REVISED SDP 2020

T.O.D. - Special Development Plan

Urban Trails

REVISIONS TO APPROVED SDP 2018-03

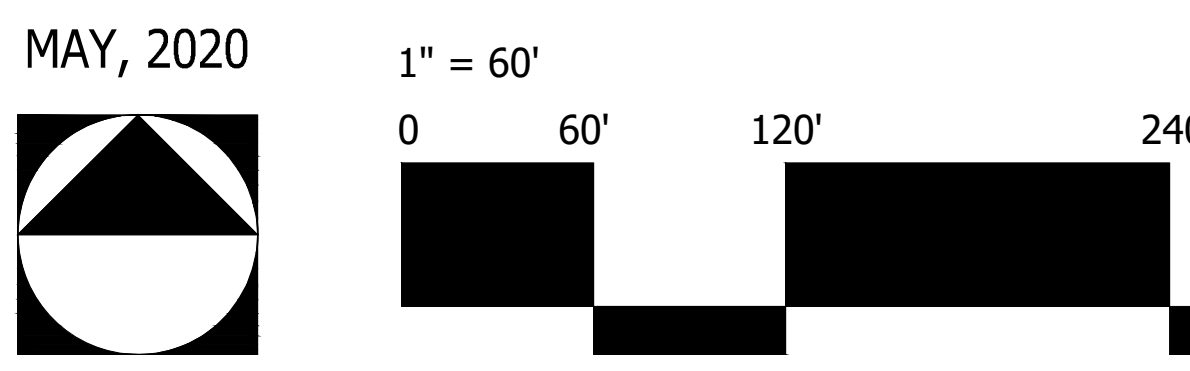
- Requesting waiver for 22' townhomes
- Requesting waiver for duplex townhomes
- Exceeds TOD standard
- Exceeds TOD standard
- Providing landscape bump outs along street
- Parking one side only, 1 space every 25'
- Exceeds TOD standard
- Additional Amenities
- 4 major entryway features
- Proposing direct access to Cottonbelt regional hike/bike trail
- Connecting sidewalks with multiple open space areas

* Requesting 9' First Floor Building Plates in lieu of 10' TOD Regulations with narrow, more dense product.

- Mitigating factors include new building elevations approval by City Council for all units facing Mid-Cities; enhancements to Central Open Space; Trail connection and enhanced Mid-Cities frontage with tree lined buffer and meandering public sidewalk (see attached plans).

ENHANCED BUILDING FEATURES

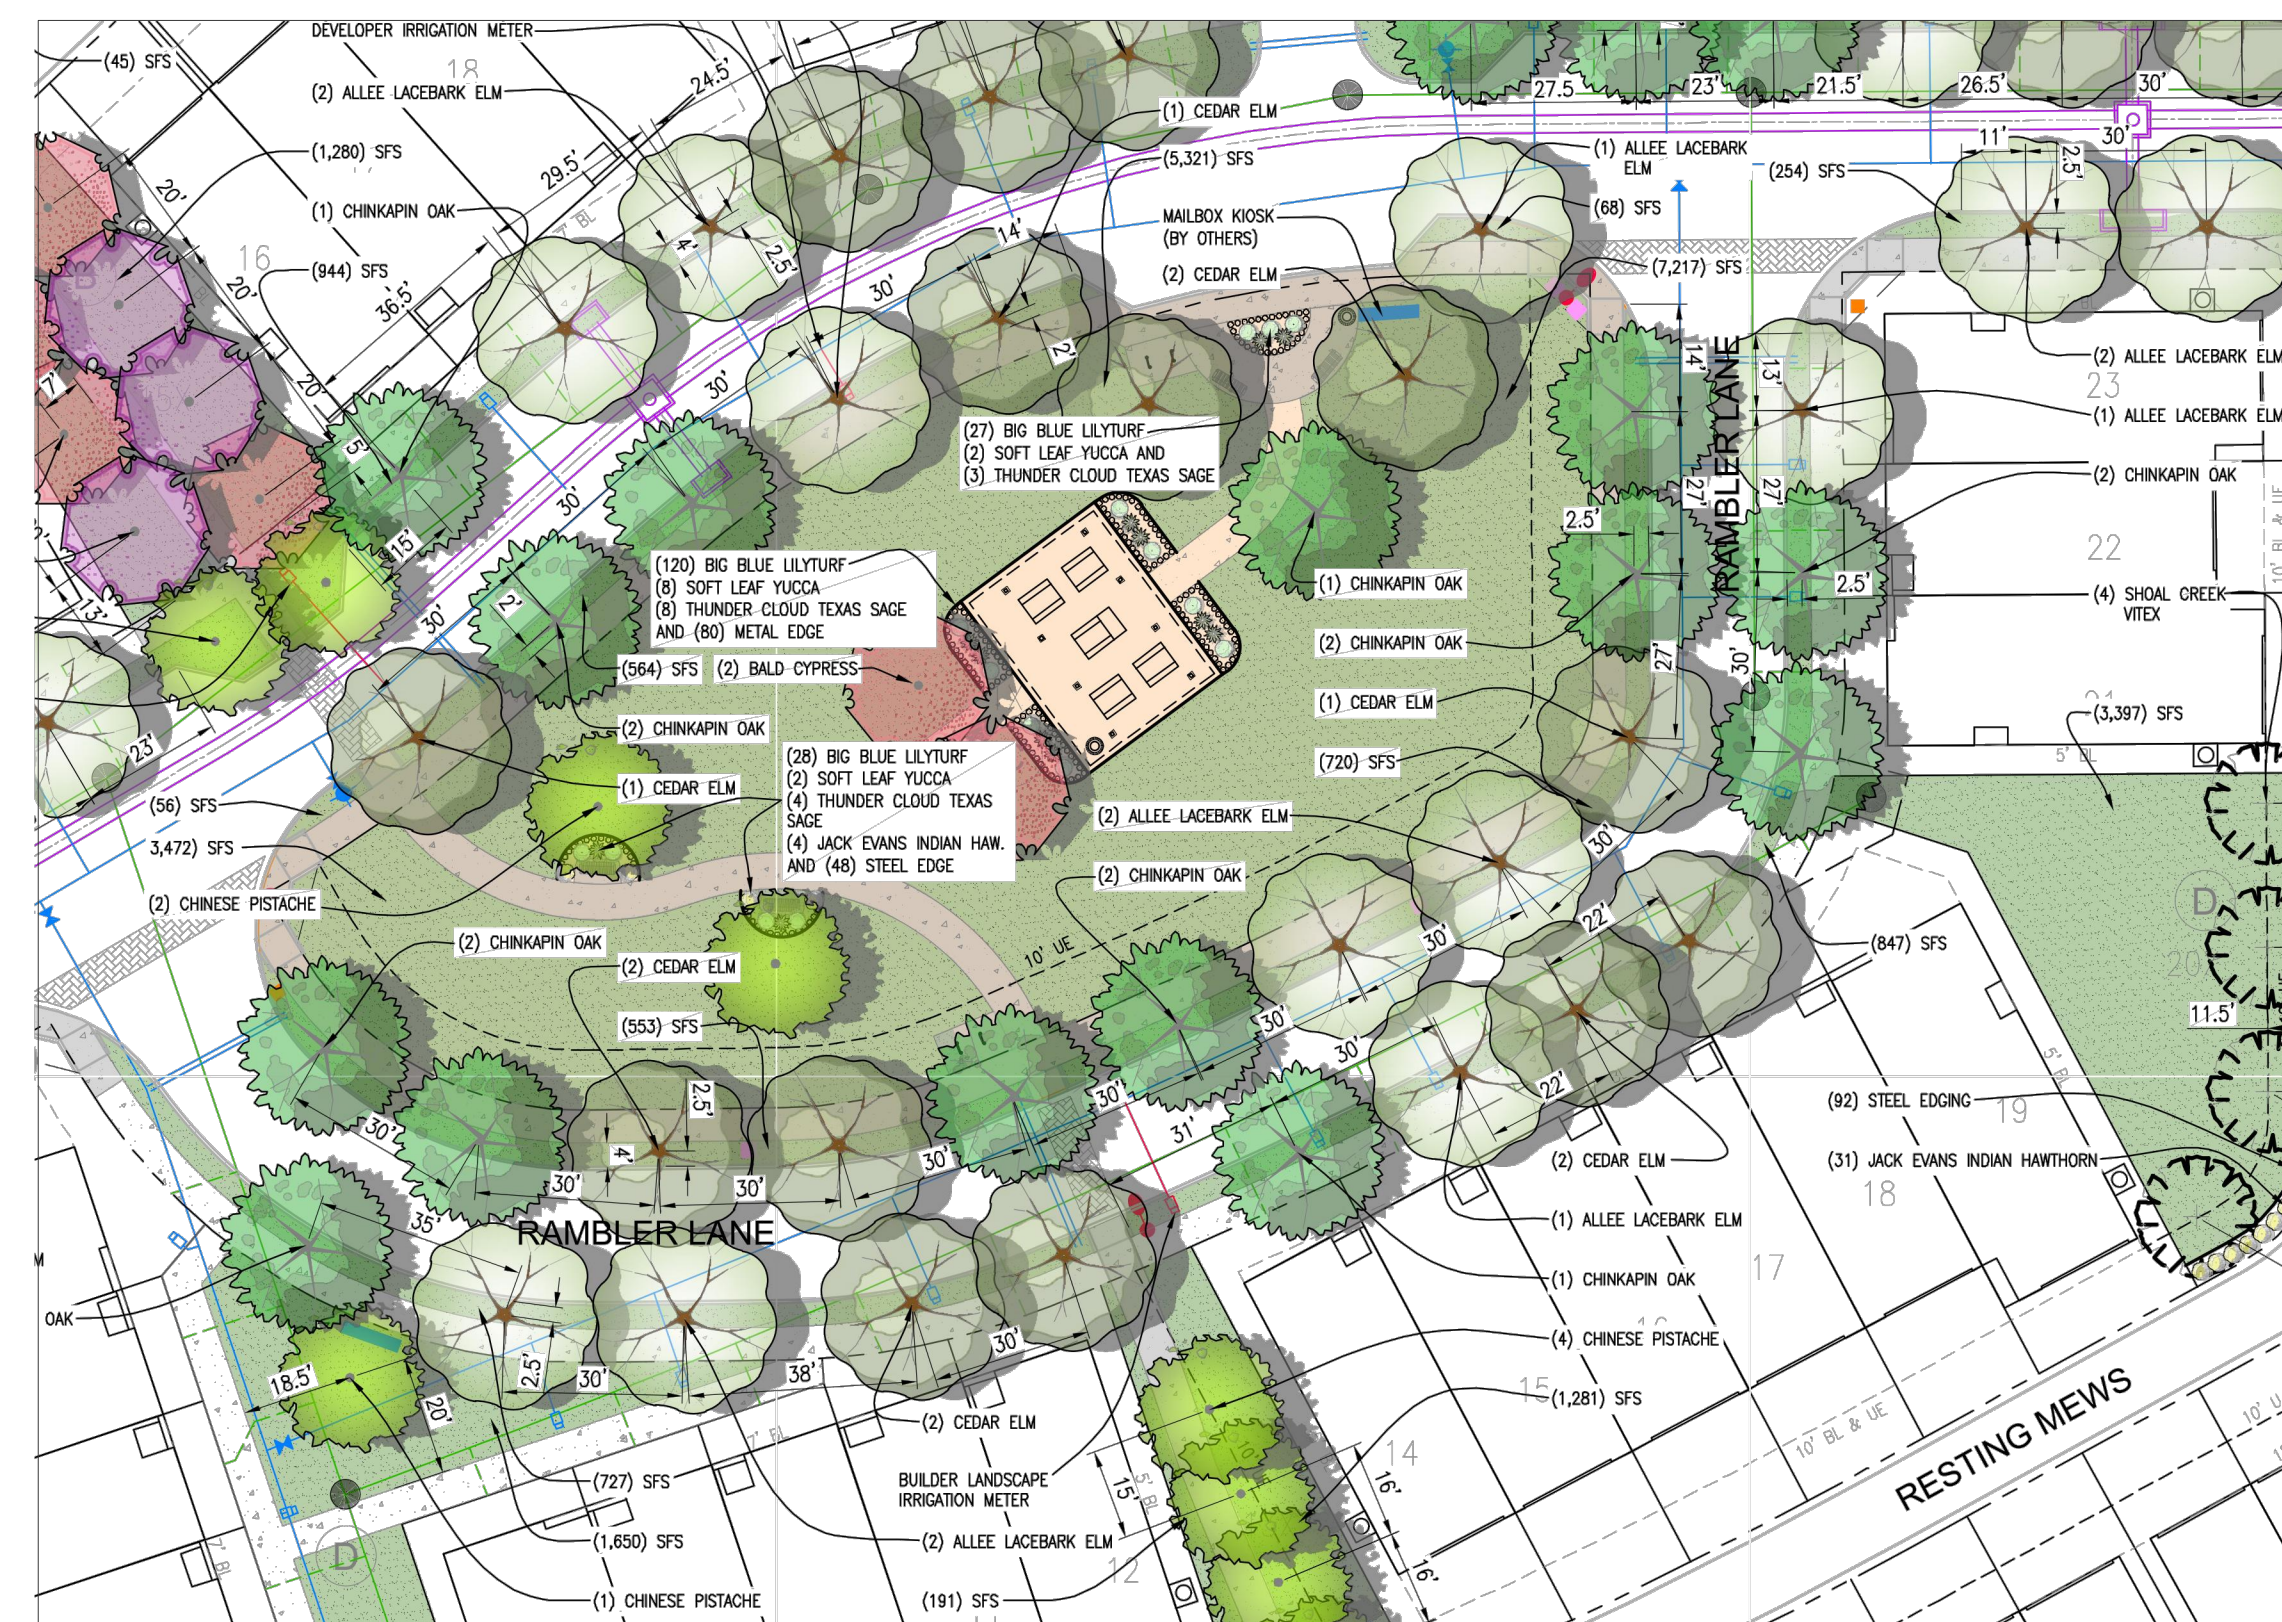
- COACH LIGHTS AT FRONT DOOR
- 8' ENTRY DOOR
- CEDAR ATTIC VENTS
- BRICK CORSE AT ROOF RAKE
- BRICK WAINSCOT
- BRICK SURROUND AT WINDOW
- COVERED PORCH
- 12:12 ROOF PITCH
- ENHANCE WINDOWS AT OPENINGS
- PIN LETTERING STREET ADDRESS
